Botley West Solar Farm

Change Request 2: Consultation Report

PINS Ref: EN010147

Document Ref: EN010147/APP/16.4

Appendix 10 - Change 10

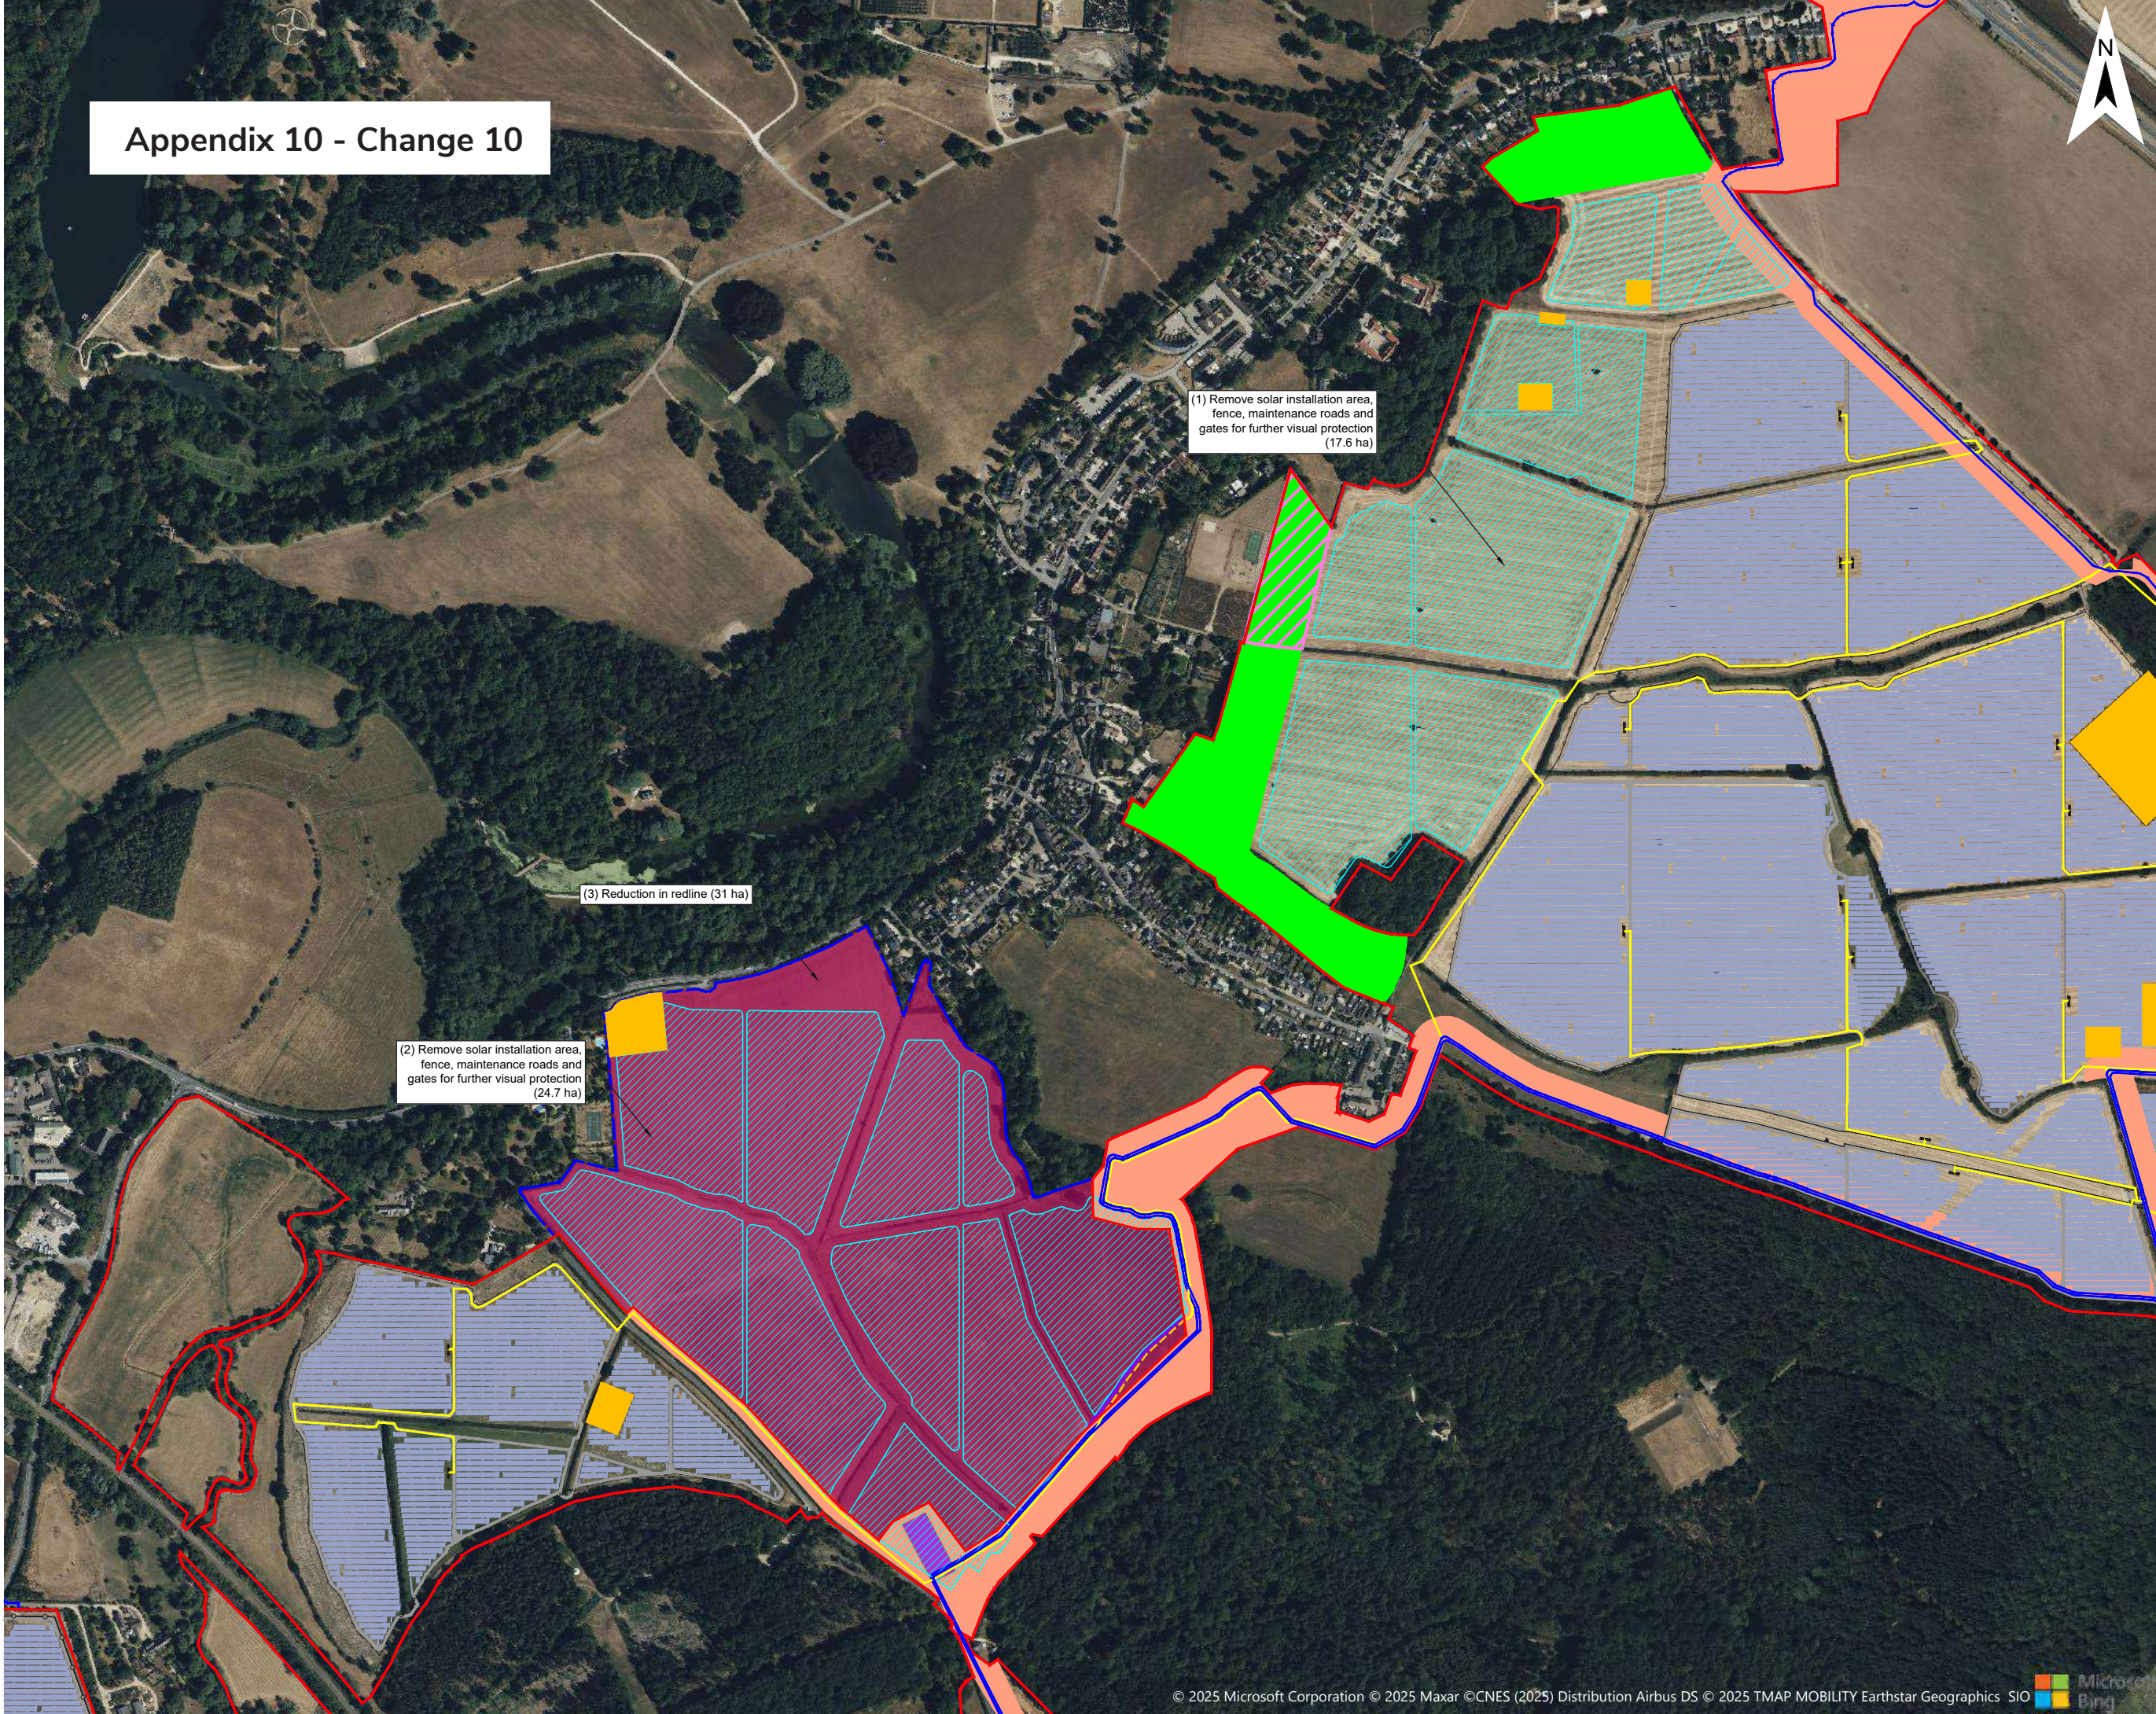
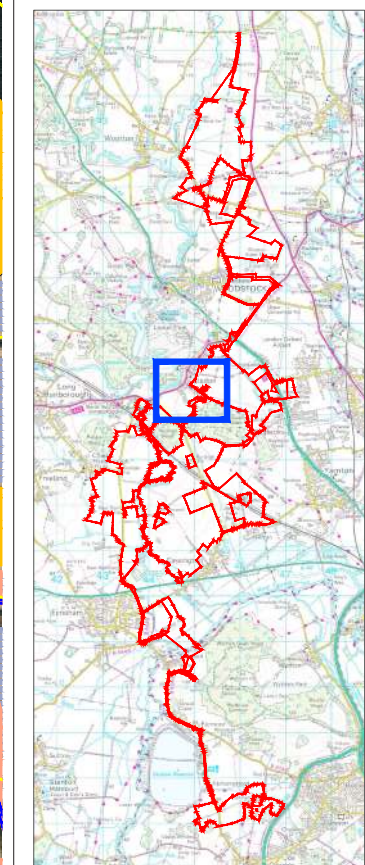
Change 10: Clarification of the role of the community educational facility

The proposed community education facility has been included in the original project, as seen in Chapter 16 of the Environmental Statement [APP-053] and the outline Operational Management Plan [APP-234] (oOMP). Illustrative 3D Views of the Educational Facility are also available at [APP-107]. As set out in Chapter 16 and the oOMP, further details (including the location, size and scale) of the facility will be finalised during the detailed design phase and included within the detailed Operational Management Plan (as secured under Requirement 12 of the draft DCO). This is explained in the Applicant's response to the ExA's Written Question Q1.7.11 submitted at Deadline 2.
